# THE GLEN AT WIDEFIELD FILING NO. 9

## RESIDENTIAL SUBDIVISION CONSTRUCTION DRAWINGS

**GLEN AT WIDEFIELD FILING NO. 9**  
**SPRING GLEN DRIVE (Sta. 30+00 to Sta. 43+00)**  
PLAN AND PROFILE  
EL PASO COUNTY, COLORADO

**GLEN AT WIDEFIELD FILING NO. 9  
BIGTOOTH MAPLE DRIVE (Sta. 25+50 to Sta. 37+82)  
PLAN AND PROFILE  
EL PASO COUNTY, COLORADO**

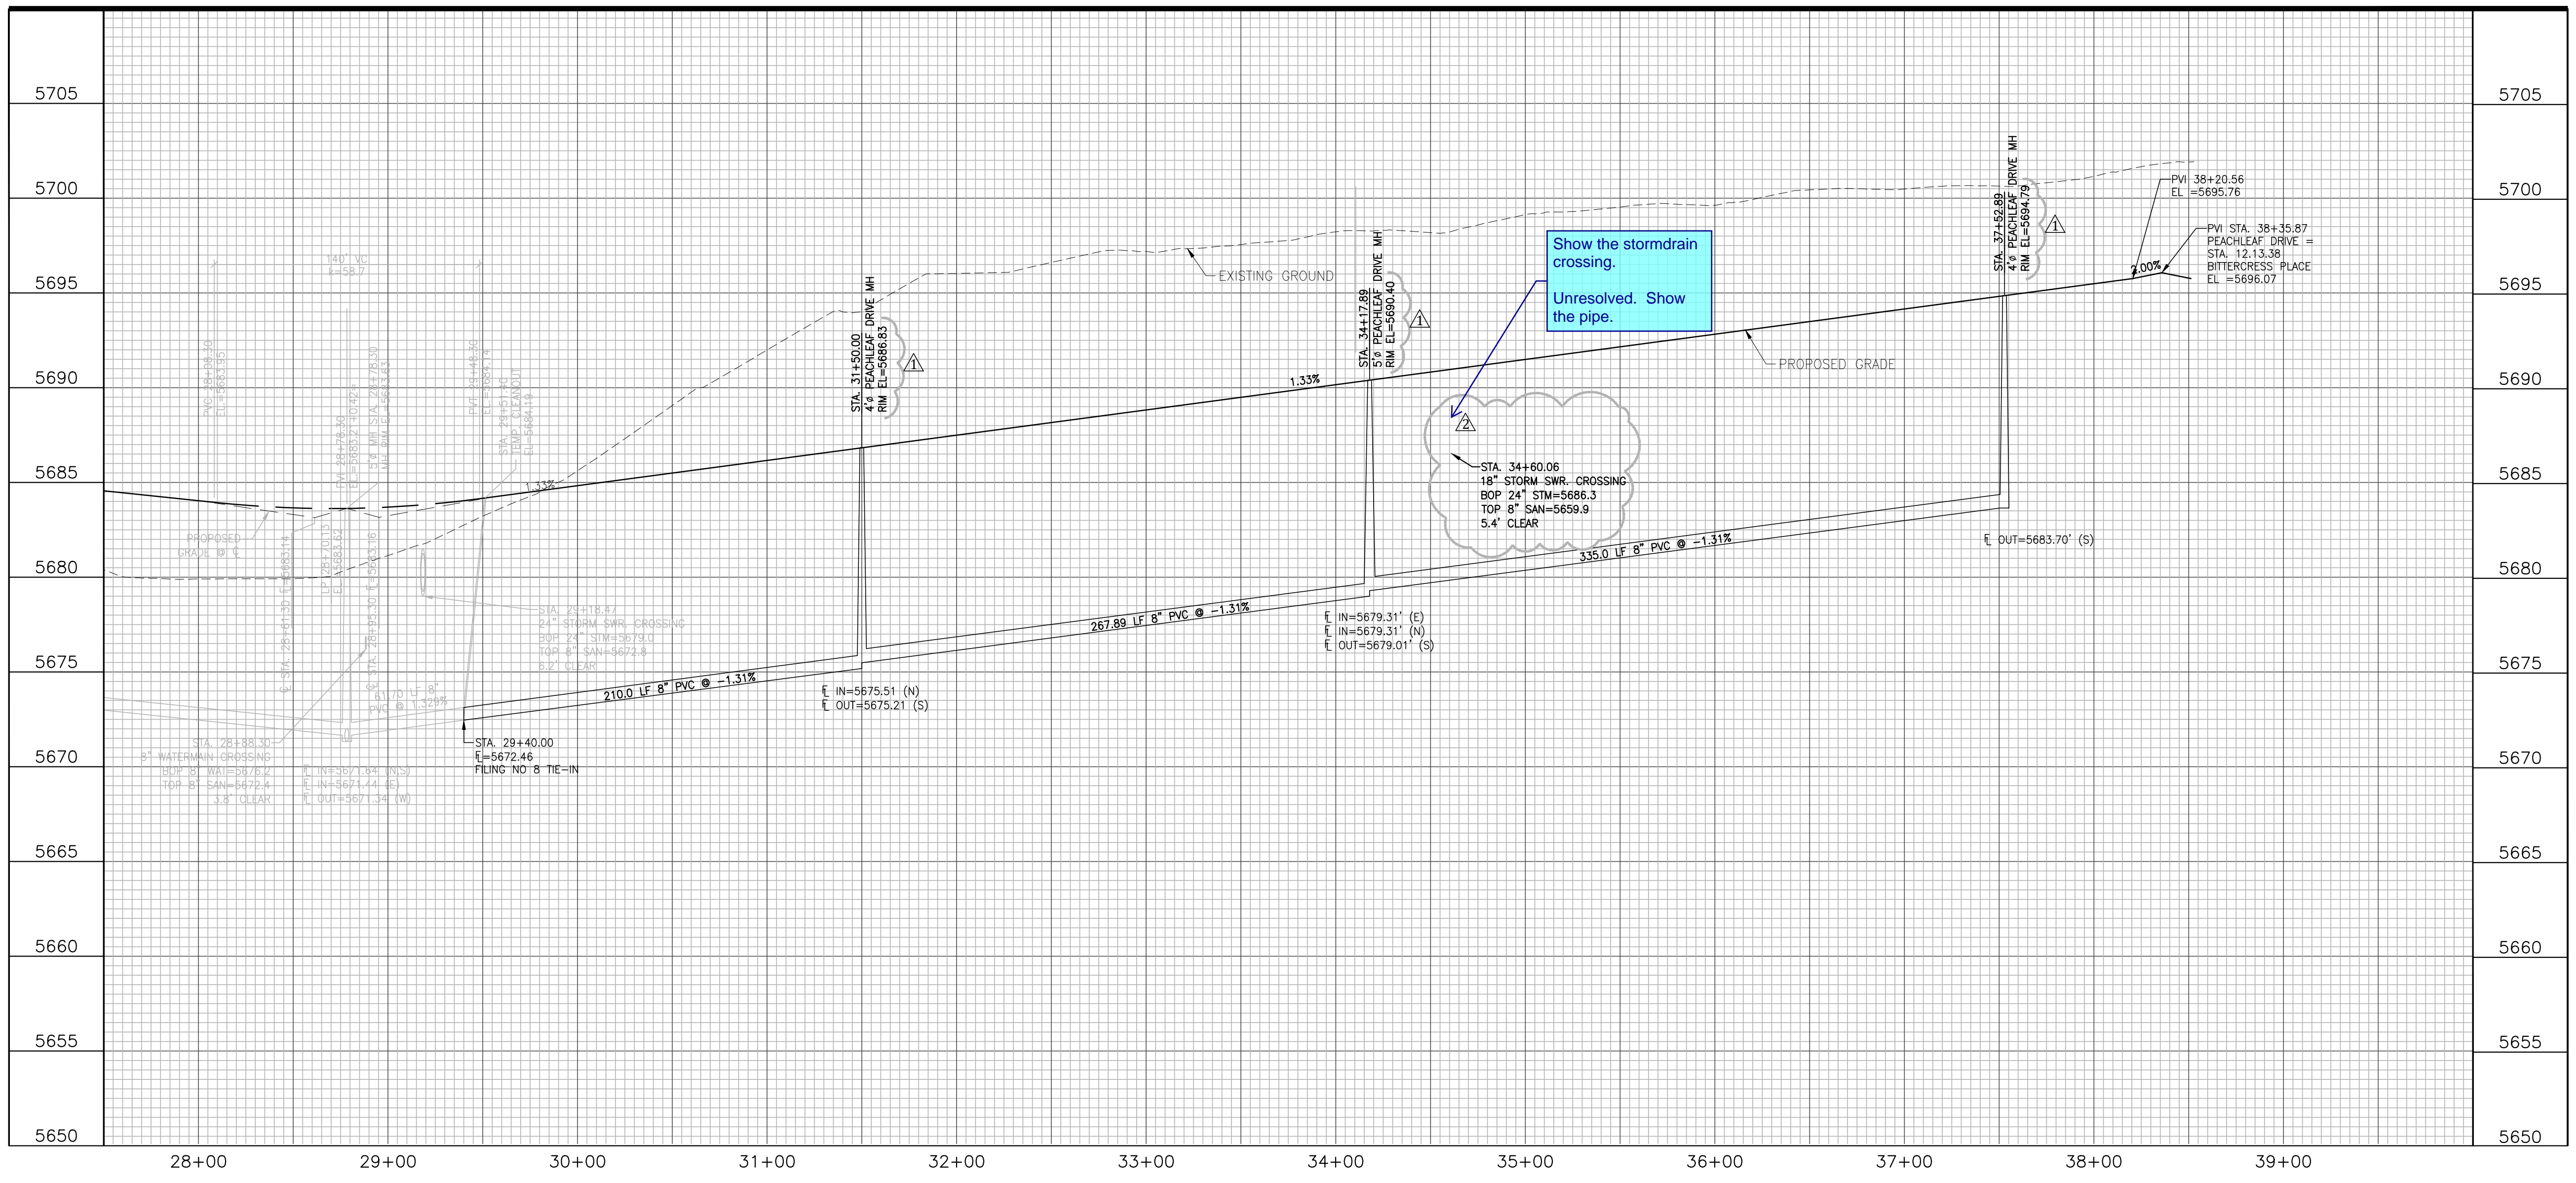
Show the stormdrain crossing.  
Unresolved. Show the pipe.

**GLEN AT WIDEFIELD FILING NO. 9**  
**BITTERCRESS PLACE (Sta. 0+00 to Sta. 9+00)**  
PLAN AND PROFILE  
EL PASO COUNTY, COLORADO

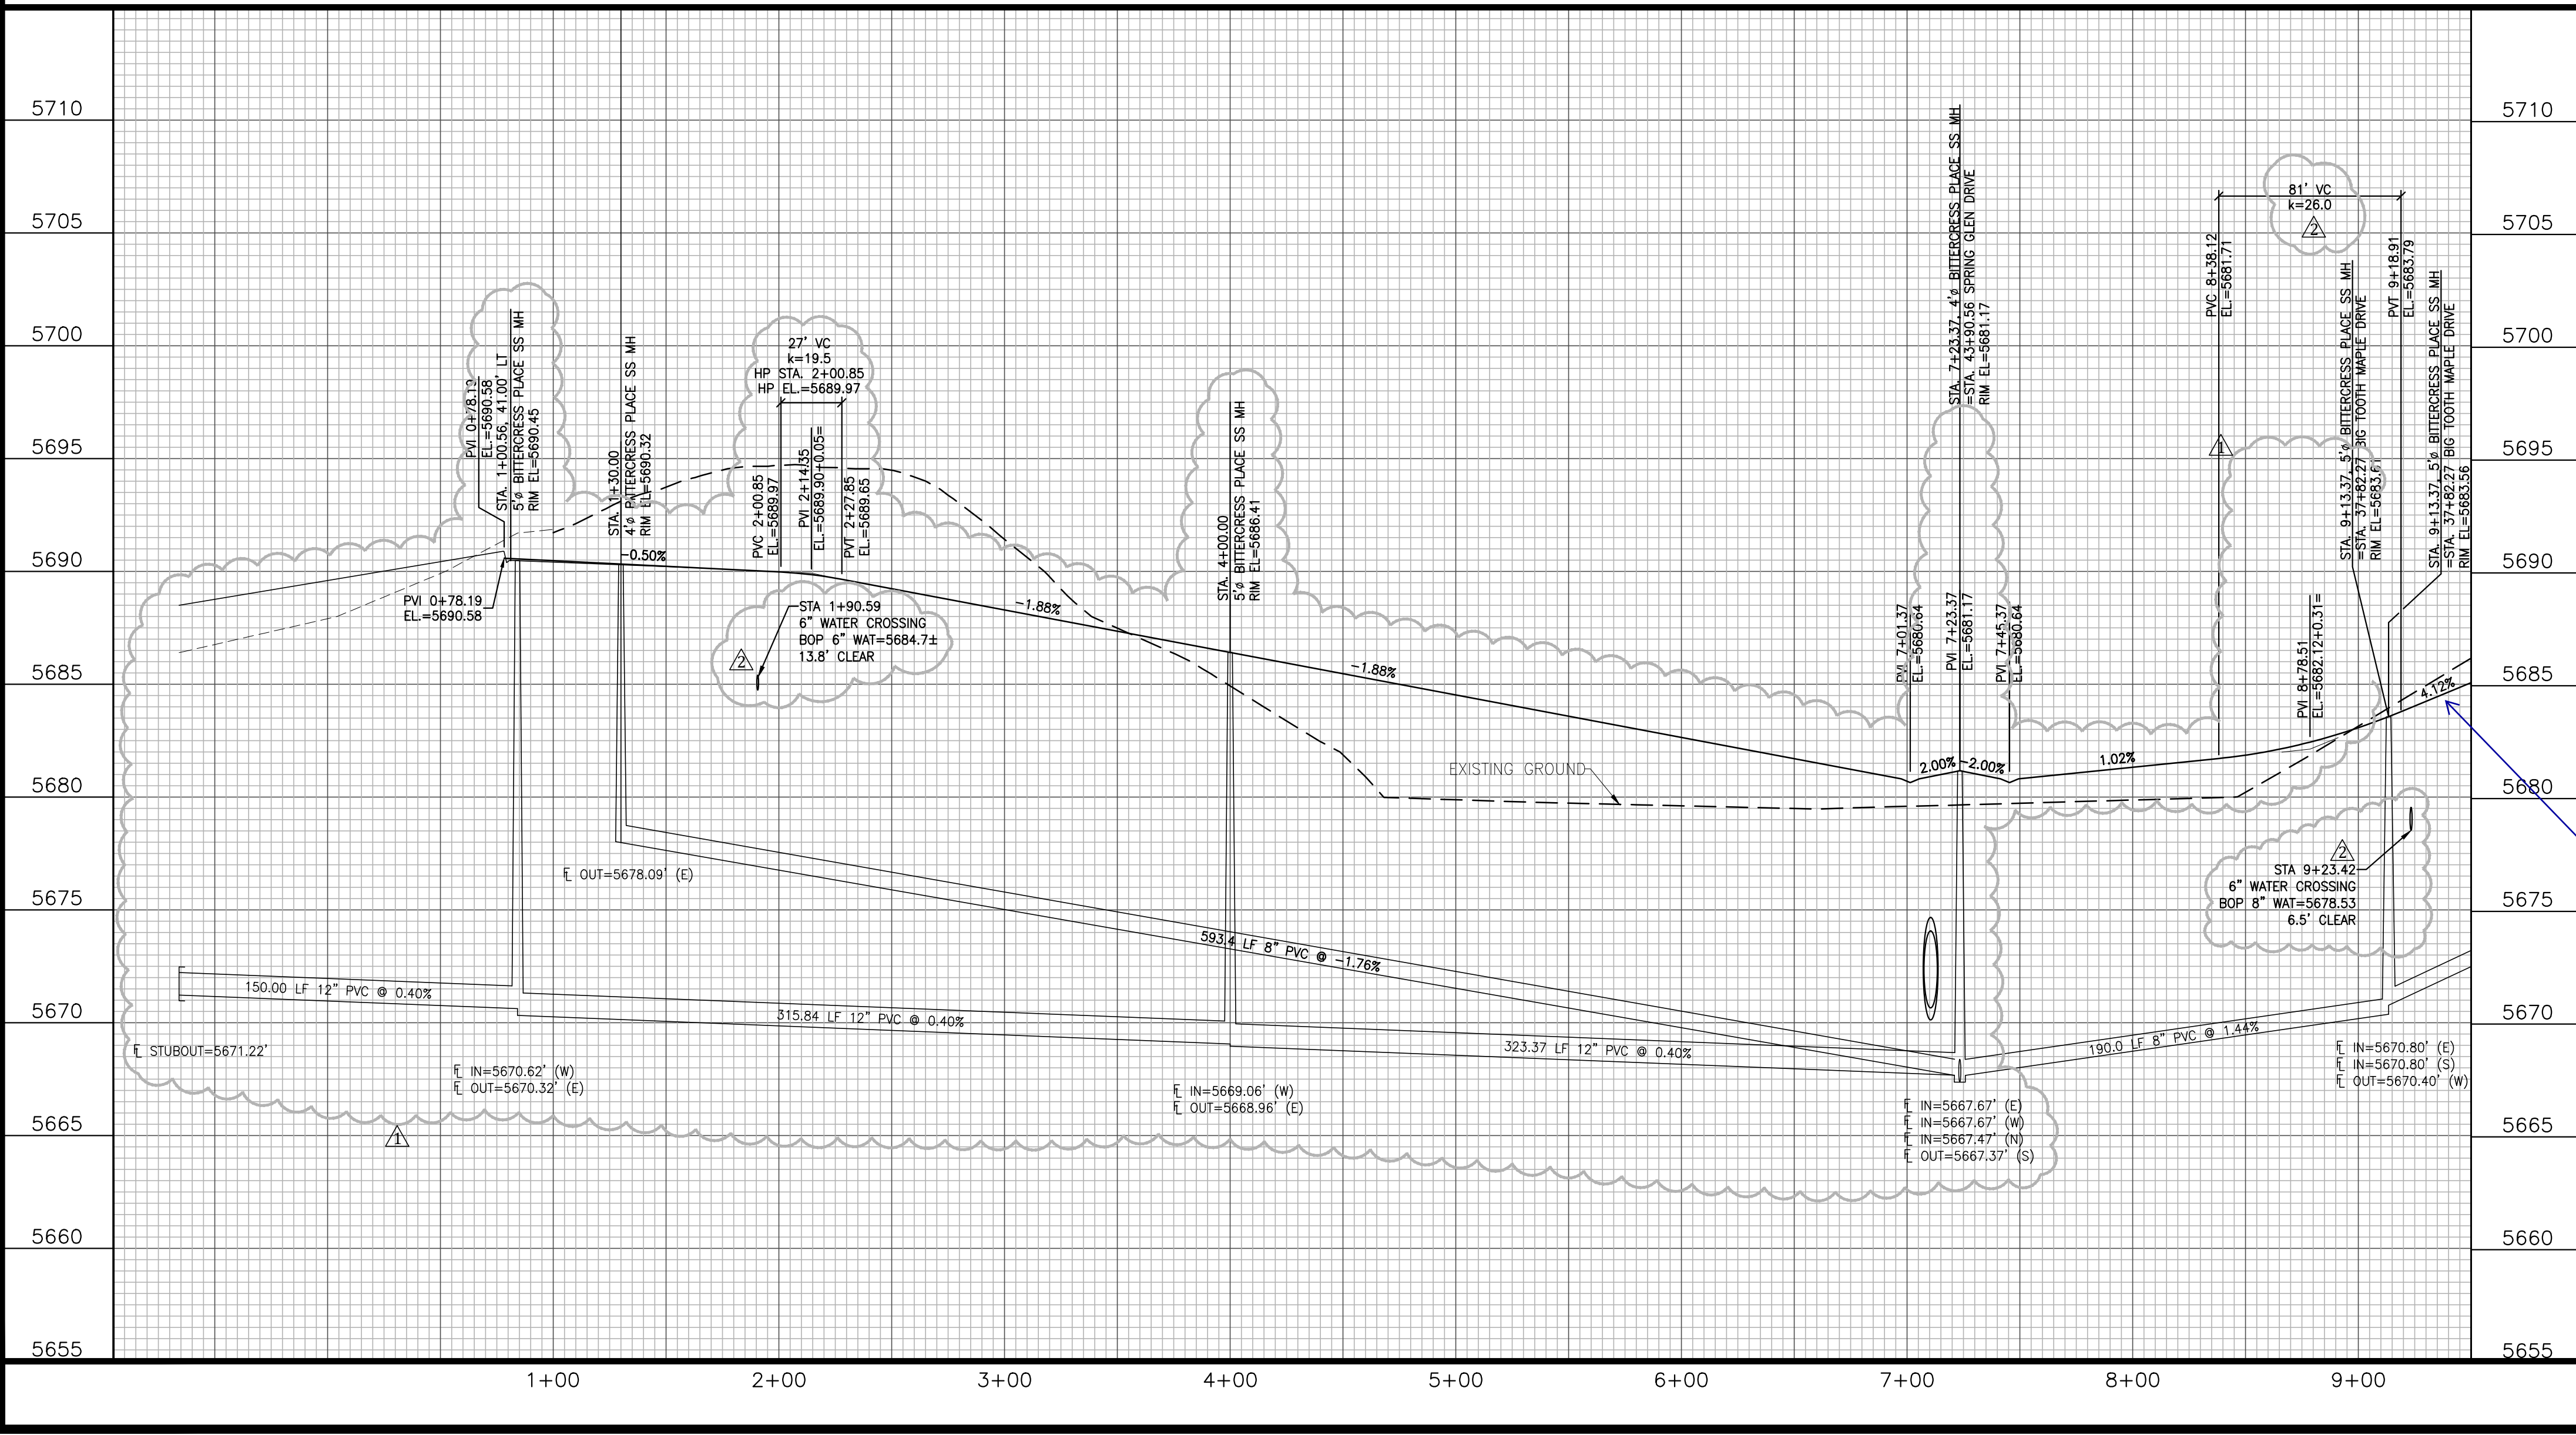
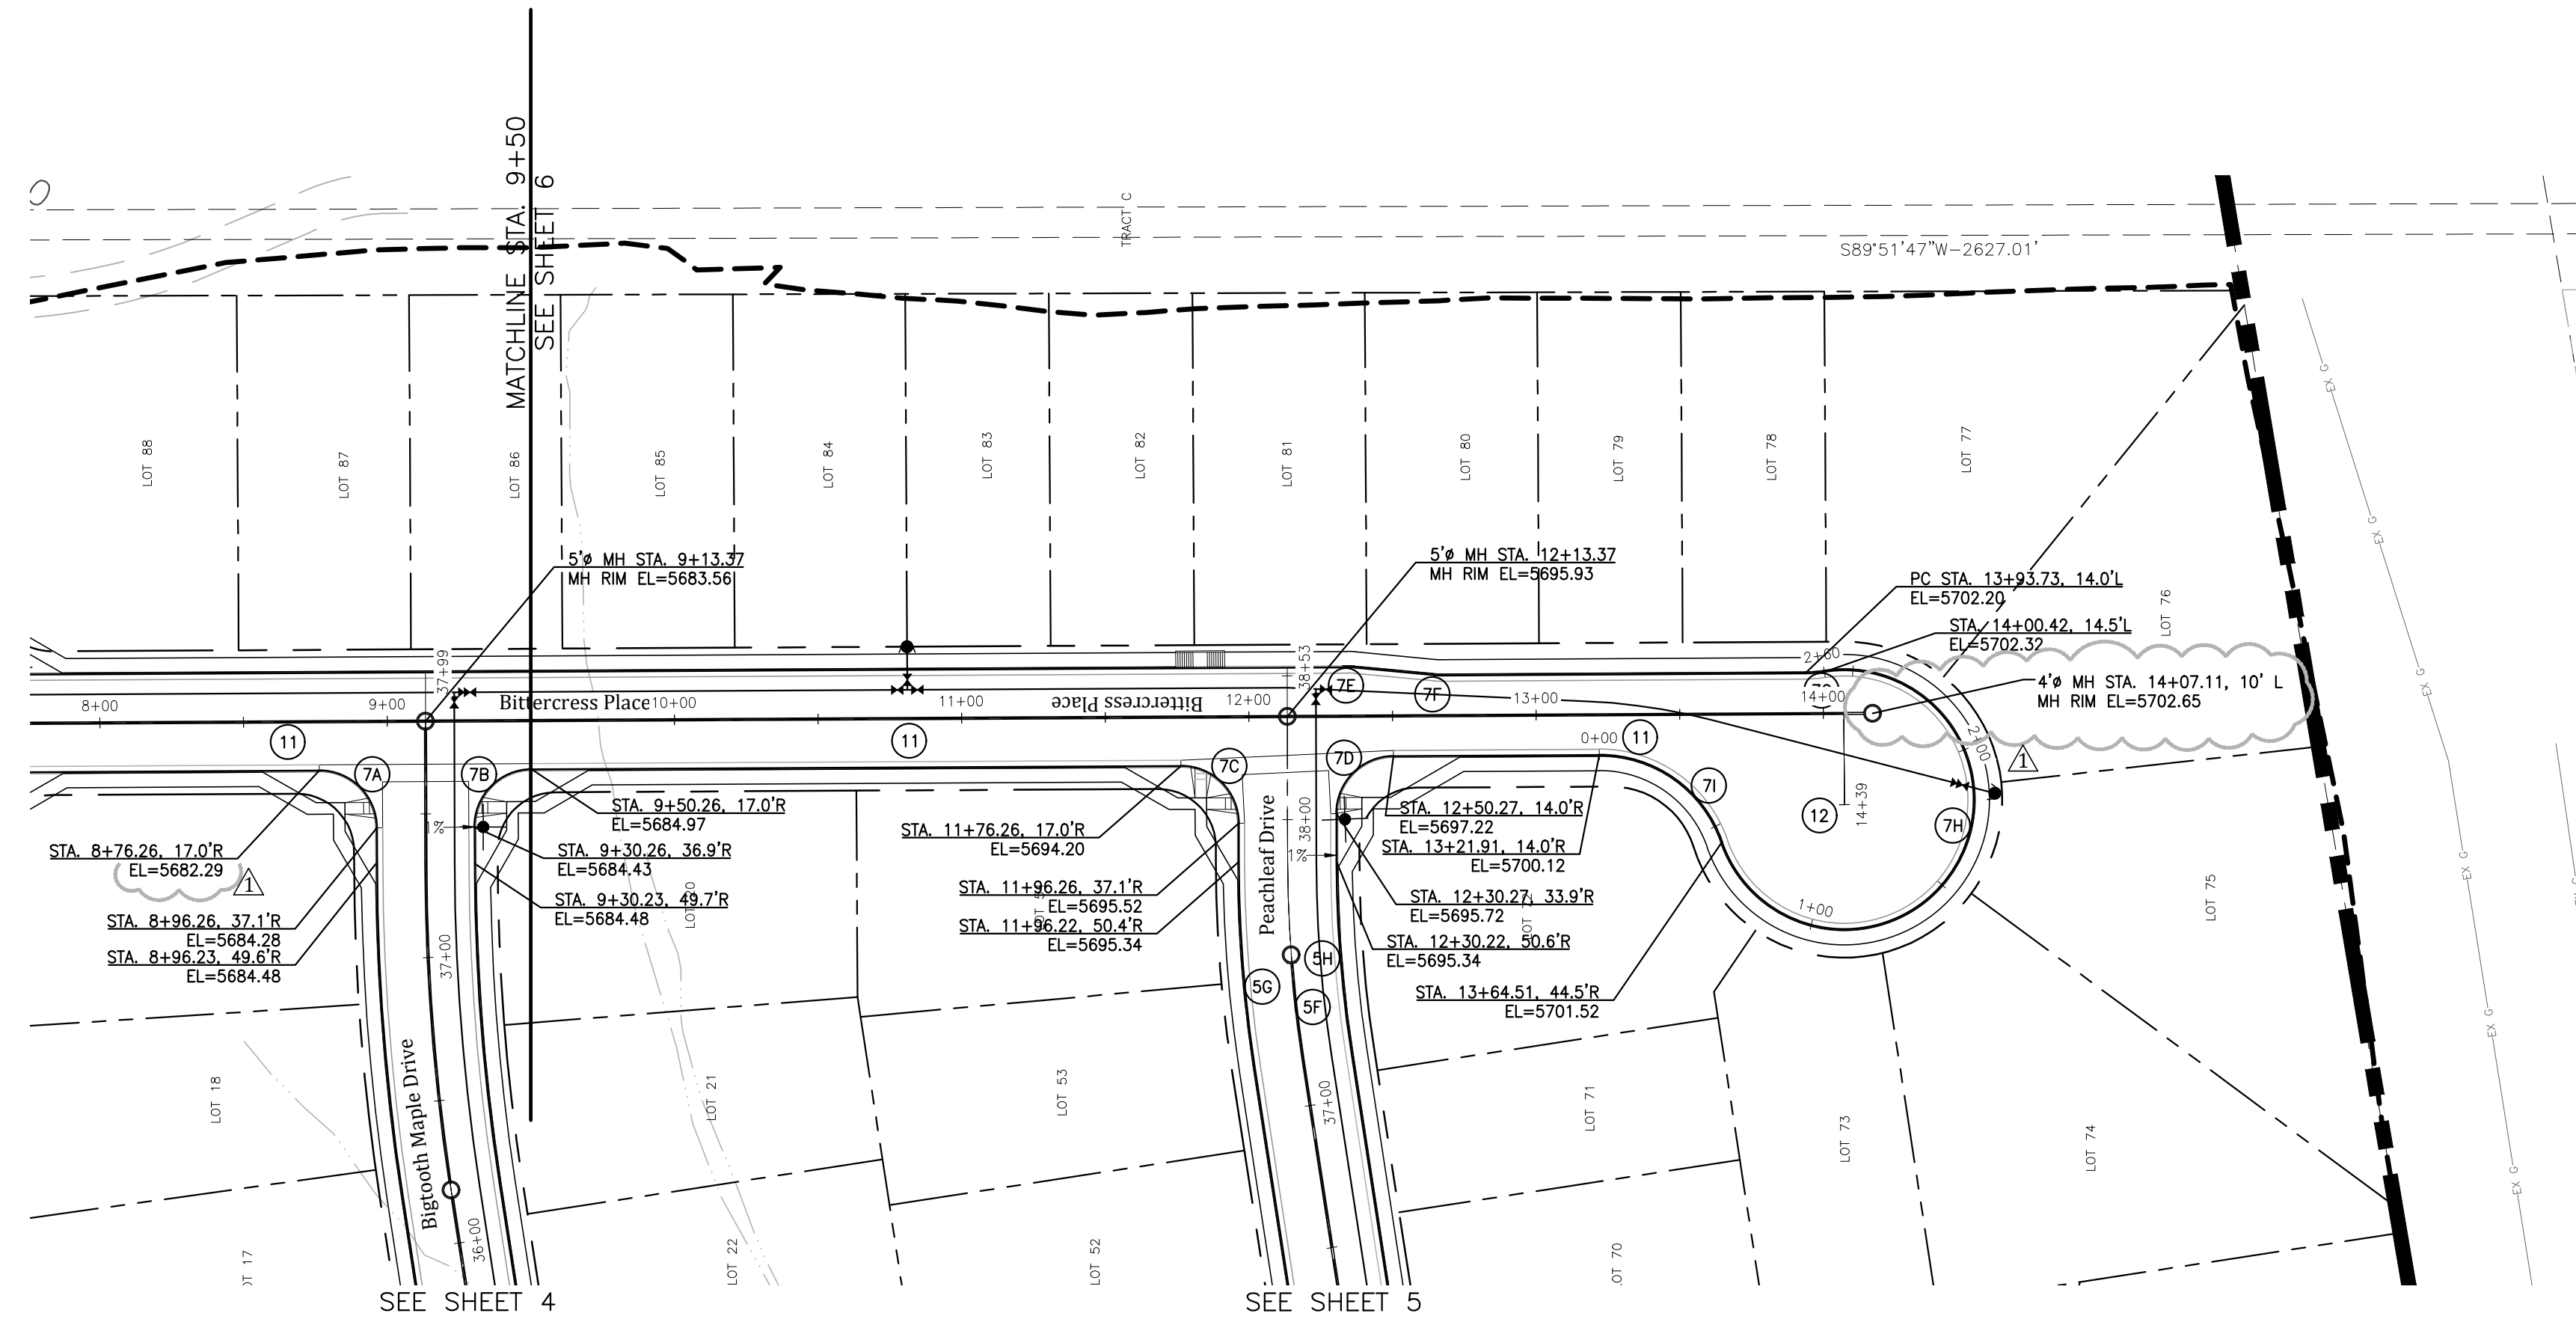
Max grade at intersections per ECM Table 2-22 is 4%.
